UNITED STATES PATENT AND TRADEMARK OFFICE

APPLICATION NO.	FILING DATE	FIRST NAMED INVENTOR	ATTORNEY DOCKET NO.	CONFIRMATION NO.
10/571,880	11/03/2006	Herbert Wehler	10016.510	2658
39231	7590	09/01/2011		
SMITH LAW OFFICE 8000 EXCELSIOR DRIVE, SUITE 301 MADISON, WI 53717				
EXAMINER				
STRIMBU, GREGORY J				
ART UNIT		PAPER NUMBER		
3634				
MAIL DATE		DELIVERY MODE		
09/01/2011		PAPER

Office Action Summary**Application No.**

FIG. 3

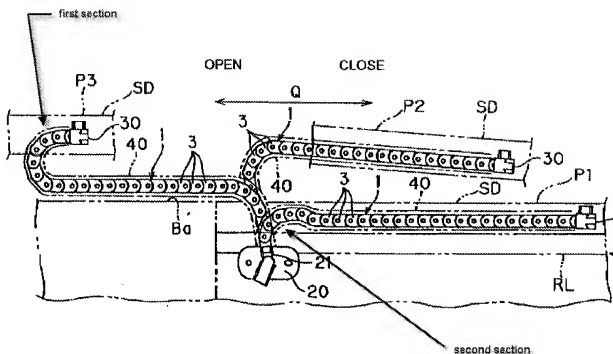
Claim 22 is rejected under 35 U.S.C. 102(e) as being anticipated by Kobayashi et al. (US 2004/0003543). Kobayashi et al. discloses an energy guide chain system for a vehicle, the vehicle having a chassis B and a sliding door SD that can be moved between a closed position and an open position on the chassis, and the energy guide chain system comprises:

a region (not numbered, but shown in figure 3) between the first end and the second end and the region bends in a single direction, and the region has a first section (labeled below) that defines a first radius of curvature when the sliding door is in the open position, and a second section (labeled below) that defines a second radius of curvature when the sliding door is in the closed position.

The applicant's comments concerning claim 22 are not persuasive. The energy guide chain of Kobayashi et al. bends in a single direction as much as the applicant's energy guide chain bends in a single direction. Note that the bends of the energy guide chain of Kobayashi et al. are directed toward the right, i.e., the same direction, in figure 3.
